# RENOVATION OF GALEHOUSE (A BUILDING), MCLEOD (S BUILDING), AND NATURAL SCIENCES (N BUILDING)

Cape Fear Community College Wilmington, North Carolina SCO #17-18154-01A; NCCCS #2352 BMG Project No. 2018023.00

#### **ADDENDUM NO. 1**

E118A

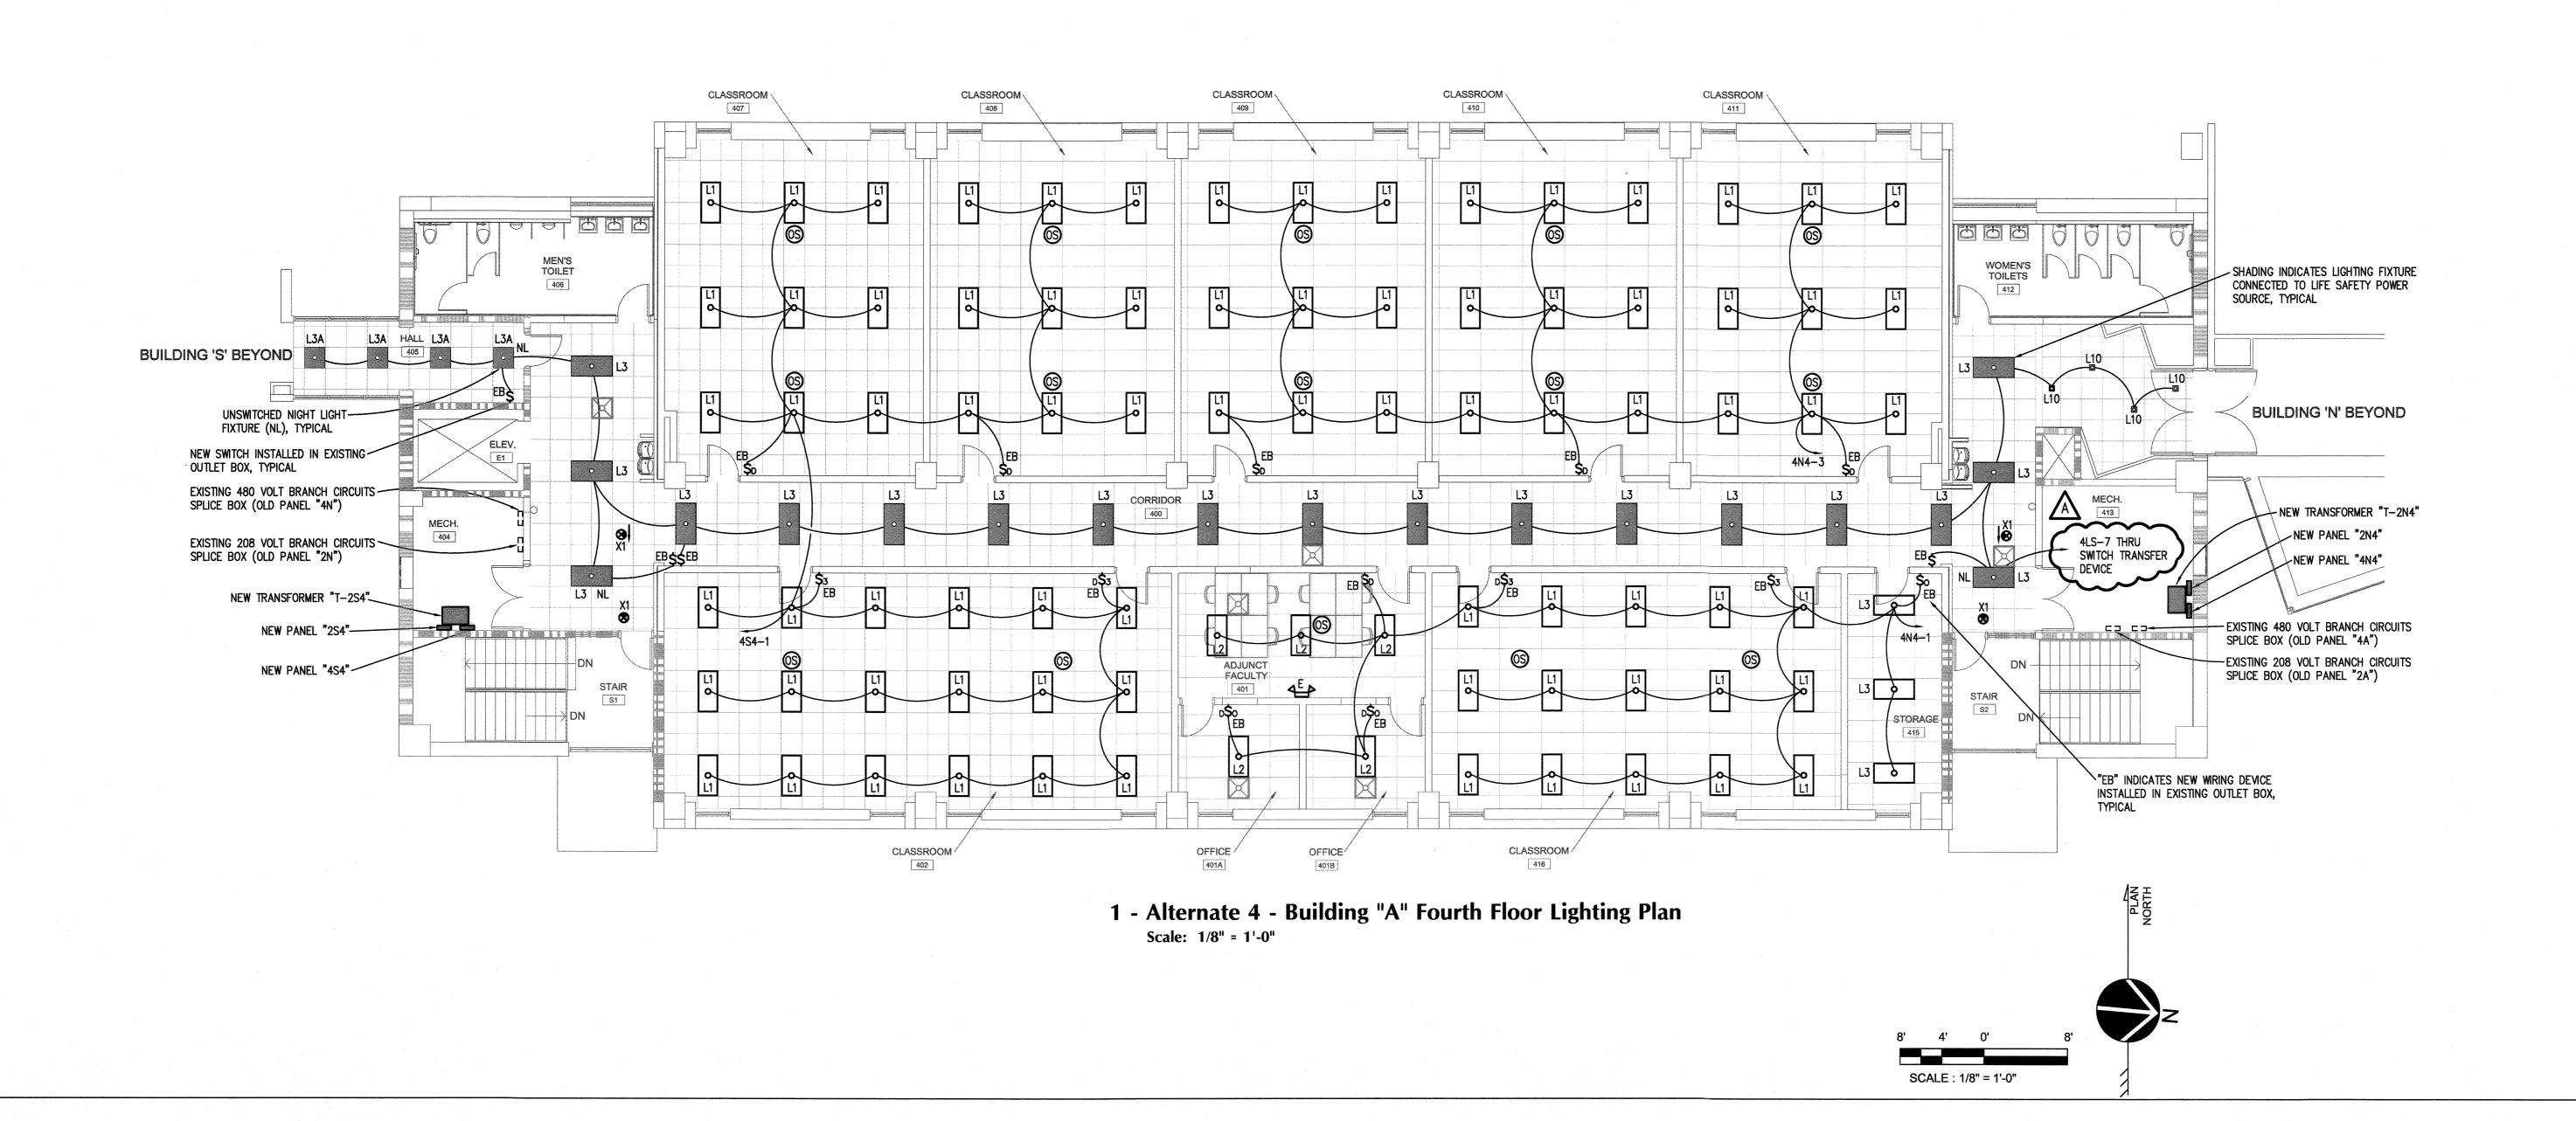
- w. E117A ALTERNATE 3 BUILDING "A" THIRD FLOOR LIGHTING PLAN: REVISED. Added switch transfer device locations.
- x. E118A ALTERNATE 4 BUILDING "A" FOURTH FLOOR LIGHTING PLAN: REVISED. Added switch transfer device locations.
